*Energy Harbor Nuclear Corp.
Beaver Valley Power Station
P.O. Box 4
Shippingport, PA 15077*

June 14, 2021
L-20-295

Beaver Valley Power Station, Unit Nos. 1 and 2
Docket No. 50-334, License No. DPR-66
Docket No. 50-412, License No. NPF-73
Emergency Plan Amendment Request

Subject: Request for licensing action to revise the Beaver Valley Power Station, Emergency Preparedness Plan to reduce on-shift staff positions, extend augmented Emergency Response Organization (ERO) response times, and re-align augmented ERO response positions.

3.3 EMERGENCY MEASURES

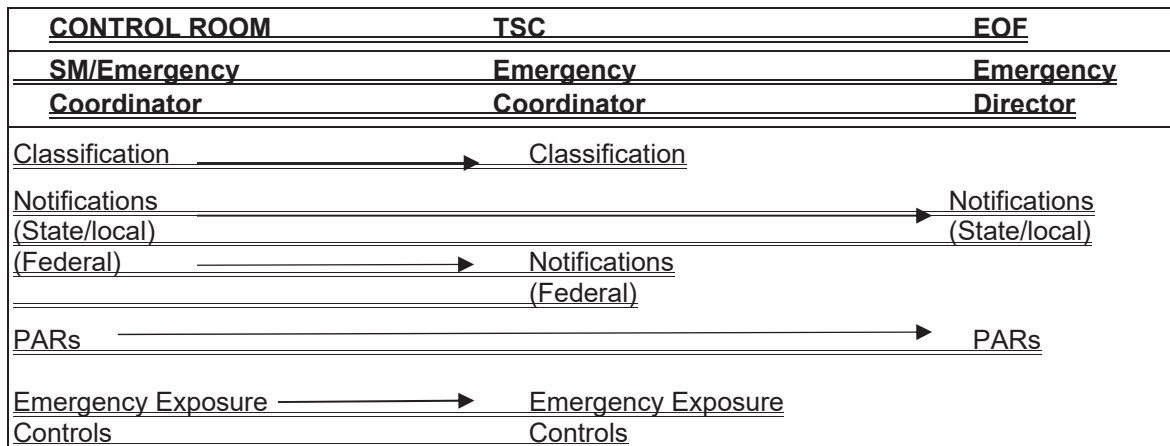
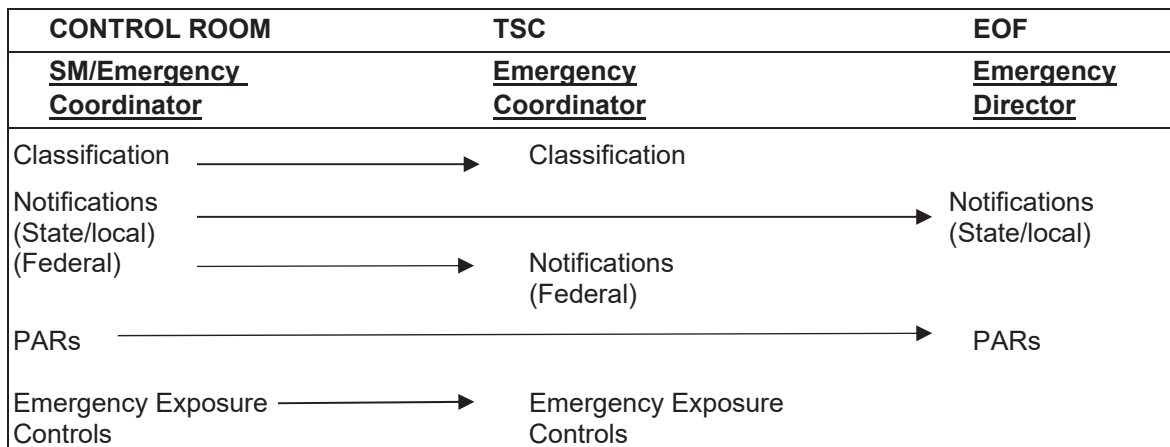
- m. Section 3.3, Emergency Measures, revised sub-sections 3.3.1, 3.3.2, 3.3.3, 3.3.5, and 3.3.6 to reflect activation of the TSC, OSC, and EOF at an Alert or higher classification added diagram to outline transition of command and control functions from the CR to the TSC and EOF and revised ERO titles.

FIGURE 5.1
BEAVER VALLEY POWER STATION ^{C62}

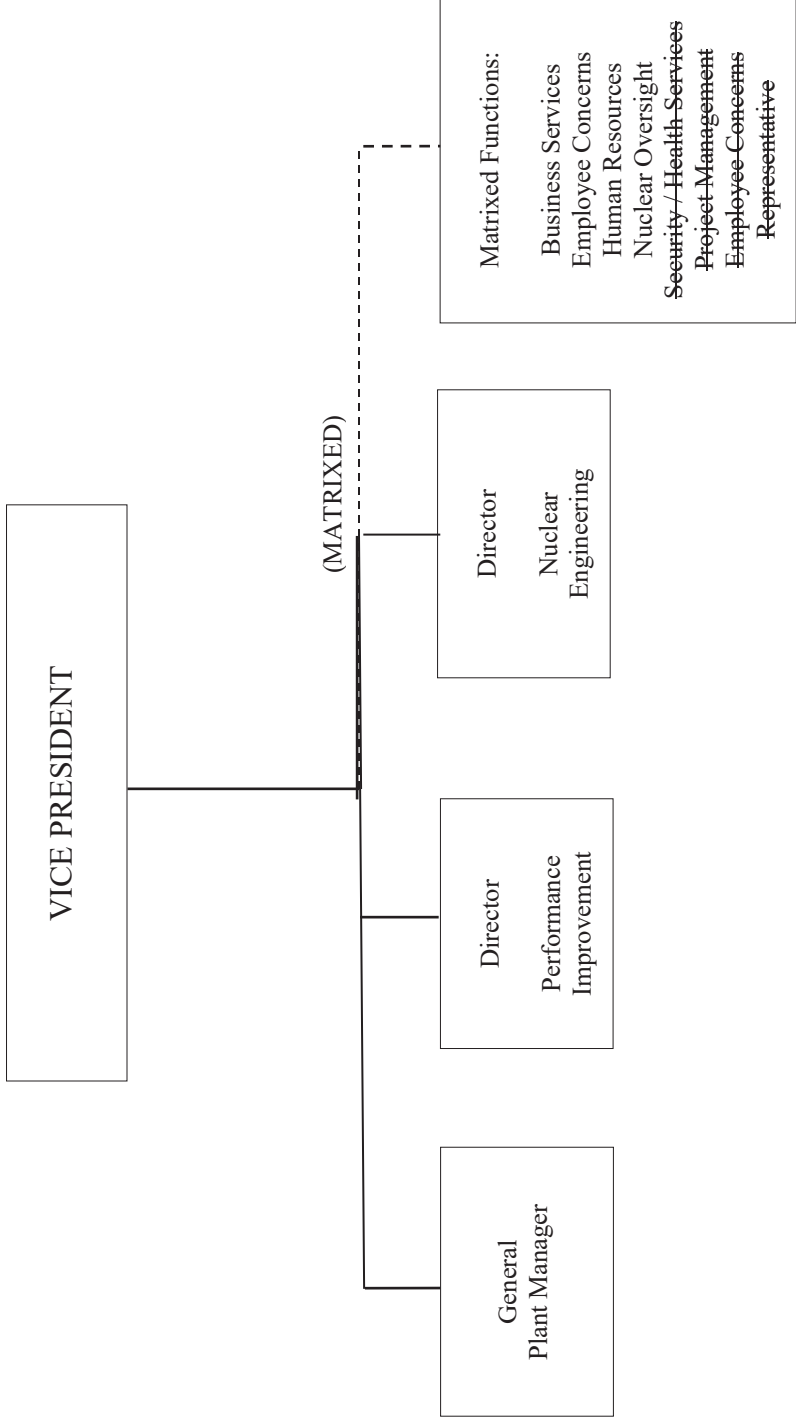
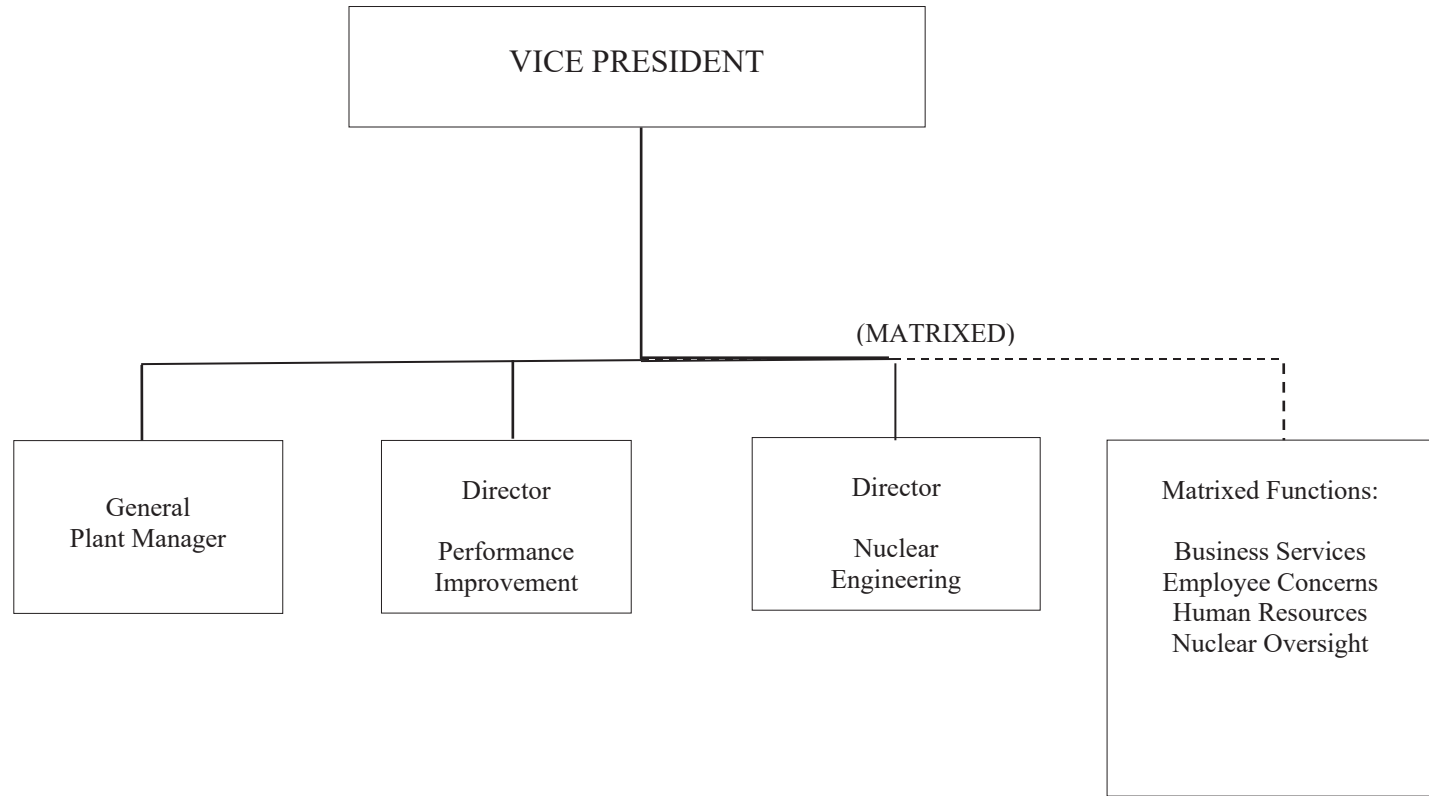
- mmm. Figure 5.1, Beaver Valley Power Station, revised to reflect the current site organization.

FIGURE 5.2
ONSHIFT EMERGENCY ORGANIZATION

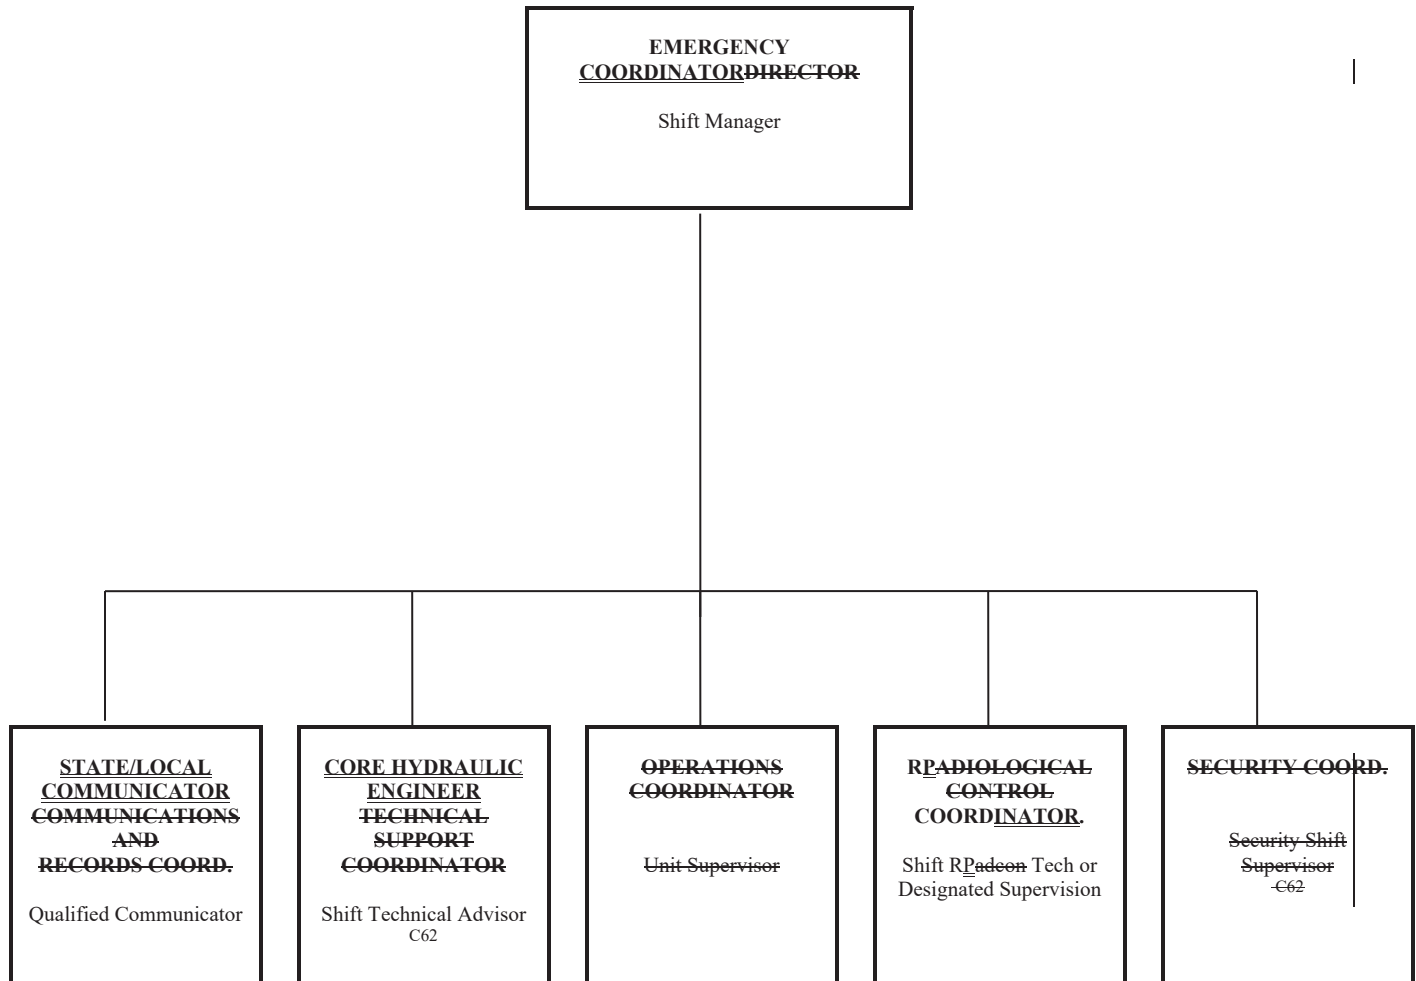
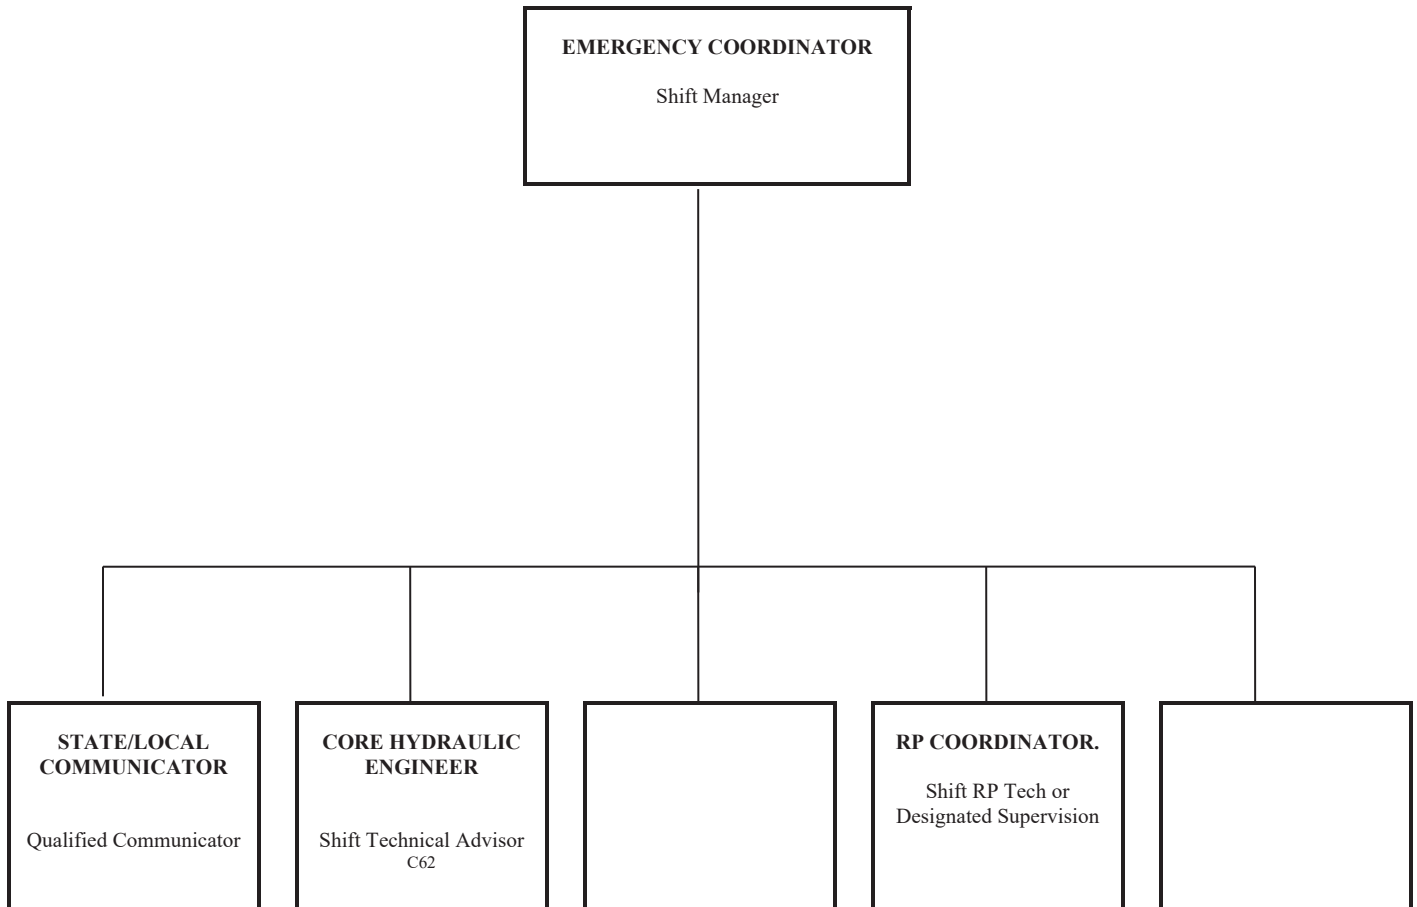
- nnn. Figure 5.2, Onshift Emergency Organization, revised to reflect position title changes and position eliminations.
- ooo. Figure 5.3, Technical Support Center Organization, revised to reflect changes in facility organization and response times.

OPERATIONS SUPPORT CENTER ORGANIZATION c8

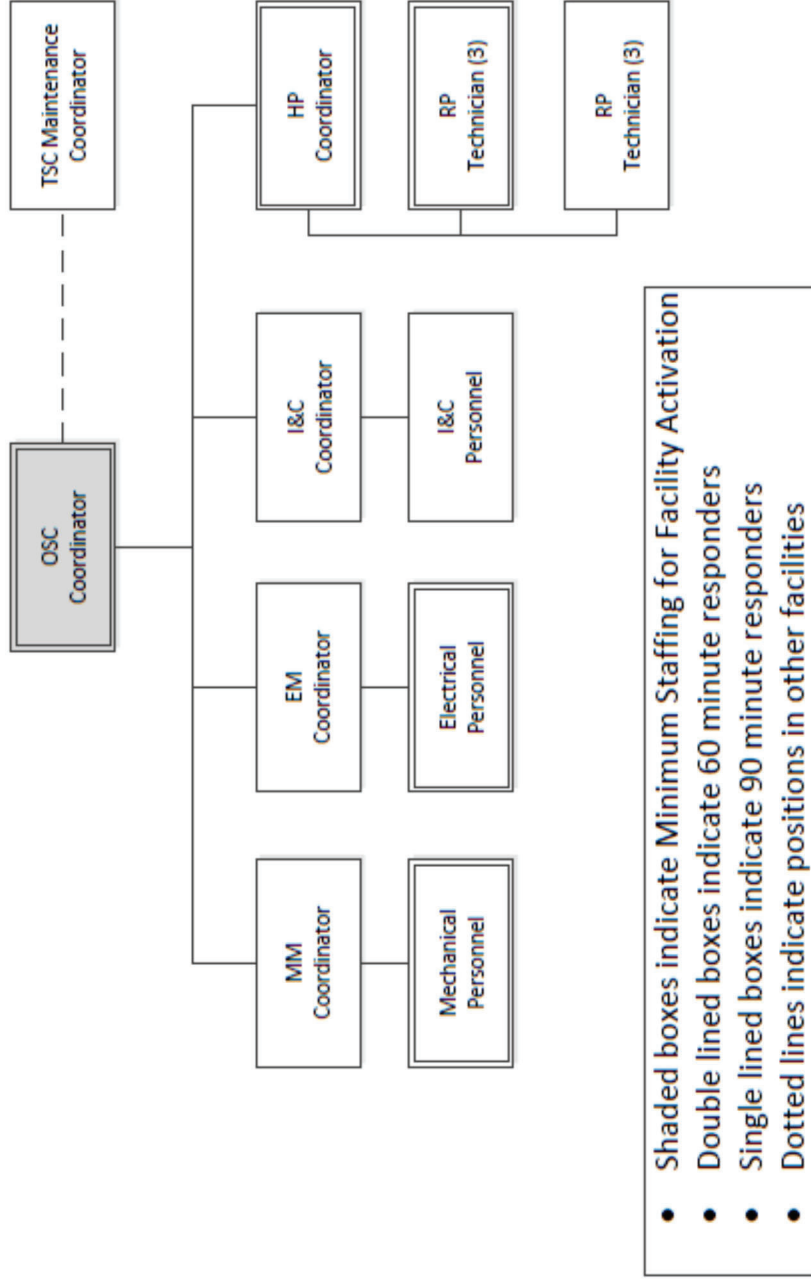
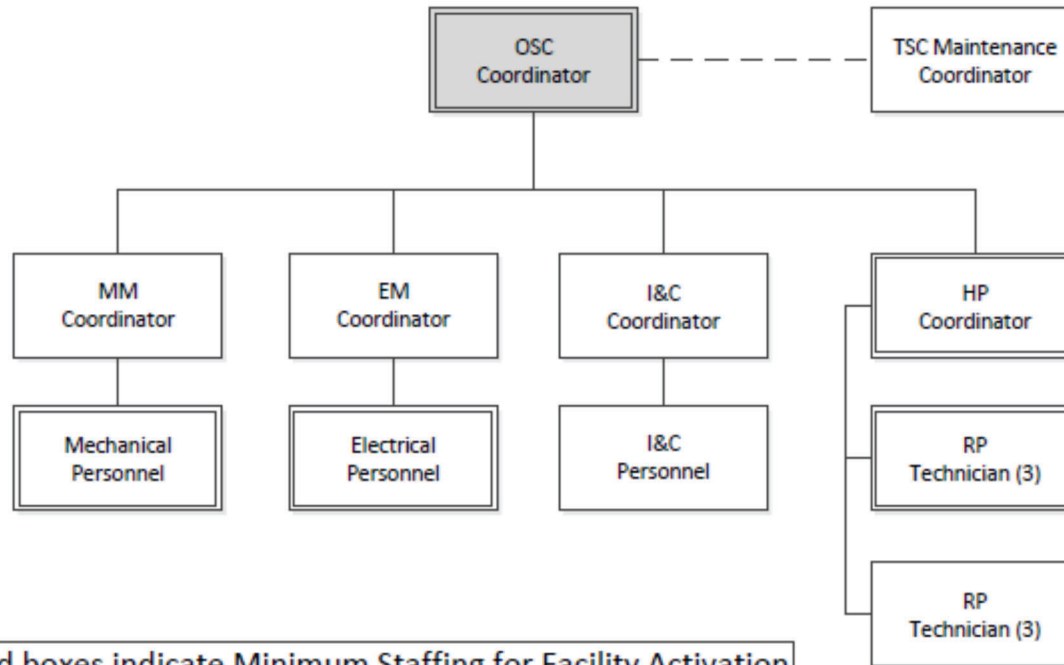
- ppp. Figure 5.4, Operations Support Center Organization, new figure that adds an organizational chart which identifies OSC staffing and response times.
